Northeast Cape HTRW Remedial Actions

Site 28 Phase I Sediment

Removal Report

Revision 2

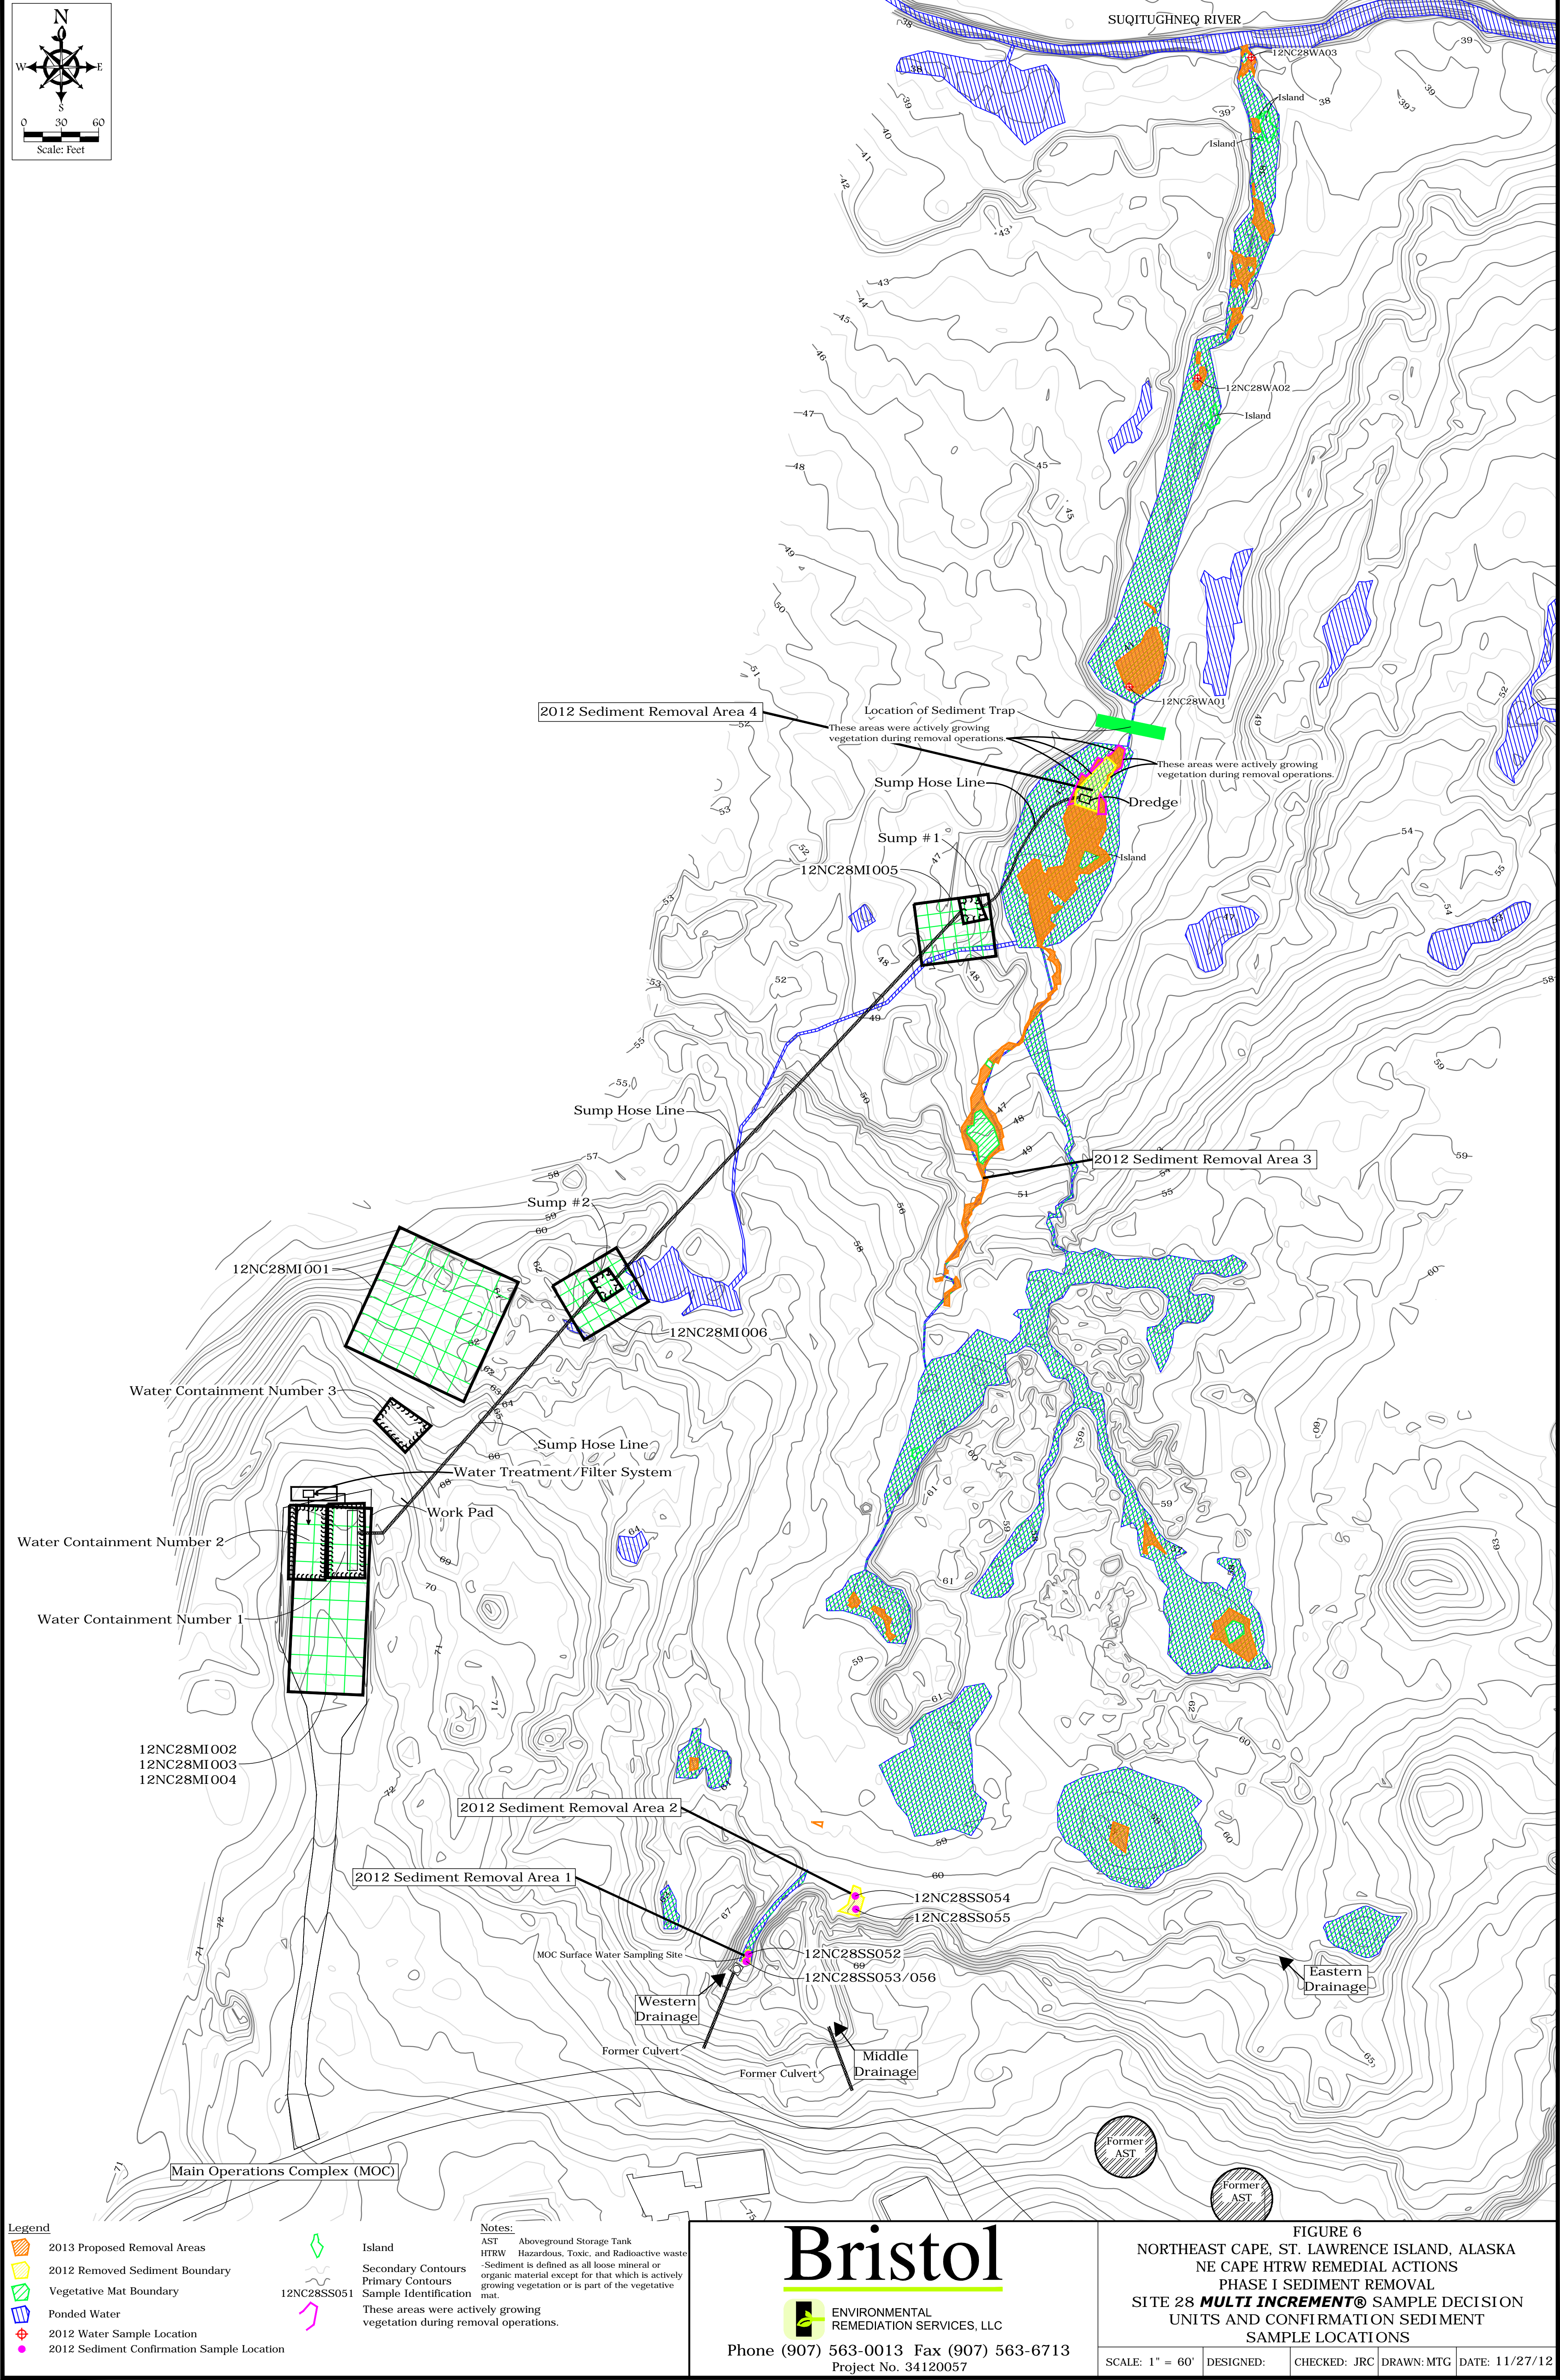
18.	Figure 5	<p>Text for sample 12NC28SS034 printed out weird. Please correct.</p> <p>The dark black lines that depict the sumps, pumps, pipelines, containments, etc. look very sloppy and unprofessional compared to the rest of the figures. Some lines do not match up with one another, can't tell what is what, etc. Need to label everything and/or add to legend and clean it up. These lines are also on Figures 6 and 7. Please make necessary adjustments to these figures as well.</p>		<p>The figure will be updated as requested.</p>	A
		----- End of Comments -----

14.	Section 4.4	Why were some sediments not removed from Area 4, specifically the sediments shown in a “ring” around the fringe of the removal area indicated on Figure 5?		The area around the removal area contained actively growing vegetation in September 2012, where none was present during the sediment mapping in July2012. The “ring” around the sediment removal area 4 consists of areas that grass grew in the stream during the two months between mapping and removal. The areas were not disturbed because of actively growing vegetation.	D – At a minimum, the texture/color of the “ring” of residual sediments shown on Figure 10 should be changed and a note added to explain the reason why the sediment was left in place. This scenario will repeat itself in 2013, so we should

25.	FIGURE 5	<p>In the title, bold "SITE 28 MULTI INCREMENT" AND replace "SEDIMENT" with "CONFIRMATION SOIL" unless samples of residual sediment instead of soil were truly collected as confirmation samples following sediment removal.</p> <p>Why does the yellow highlight of Sediment Removal Area 4 have a "ring" of orange indicating residual sediment? Bear in mind following full-scale sediment removal in 2013, the objective is to completely remove sediment leaving only soil behind, so aspects like the "ring" indicated on this figure are important and could be perceived as incomplete sediment removal.</p> <p>Label all decision units.</p> <p>Label the "Water Processing Area".</p> <p>Show a symbol indicating the dredge in Sediment Removal Area 4 as well as dredge hose leading from Area 4 to Sump #1.</p> <p>Show a symbol indicating a geotextile dewatering tube in Water Containment #1.</p> <p>Show a symbol for a water scrubber between Water Containment #1 and #2 as appropriate.</p> <p>Show all hoses that were part of the system.</p> <p>A treatment-train diagram indicating the 2012 approach would be beneficial, perhaps in the empty space available in</p>		<p>"References to "Sediment" confirmation samples will be changed to "Soil" confirmation samples on all applicable figures.</p> <p>The area around the removal area contained actively growing vegetation in September 2012, where none was present during the sediment mapping in July 2012.</p> <p>The "ring" around the sediment removal area 4 consists of areas that grass grew in the stream during the two months between mapping and removal. The areas were not disturbed because of actively growing vegetation.</p> <p>Decision units will be labeled.</p> <p>The water processing area will be labeled and more detail will be added to show the sediment collection tube, water containments, and treatment system. Arrows will be added to indicate the direction of water flow.</p> <p>A symbol will be added to the figure to represent the dredge and associated hoses.</p>	<p>D – Please see RTCs 12 and 14.</p> <p>Bristol response: confirmation samples will be referred to as "sediment", not "soil".</p>
